Product Change Notification

2024.04.17 PR5MEC25 DIN Rail bracket change

Starting from 2024 Q2, the product accessory PR5MEC25 will be changed.

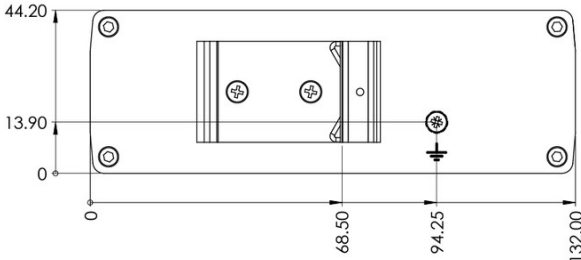
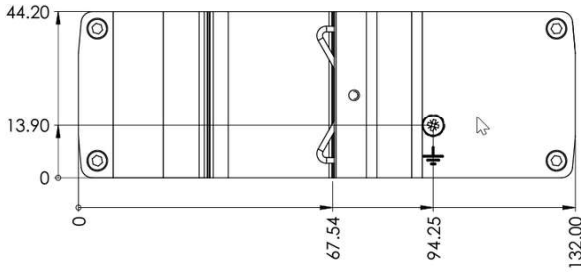
PCN Number: PCN_PR5MEC25_2024_04_17		
Change description		
Change type	Mechanical	
Detailed description	<p>Beginning in Q2 of 2024, the product accessory PR5MEC25 current screw-on DIN Rail bracket will be replaced with an integrated one. The new DIN Rail bracket will be shifted to the left by 0.96 mm.</p>	
	<p>Old DIN Rail bracket:</p> 	<p>New DIN Rail bracket:</p> 
	<p>Dimensions of old DIN Rail bracket:</p> 	<p>Dimensions of new DIN Rail bracket:</p> 
	Change reasons	Structural improvement
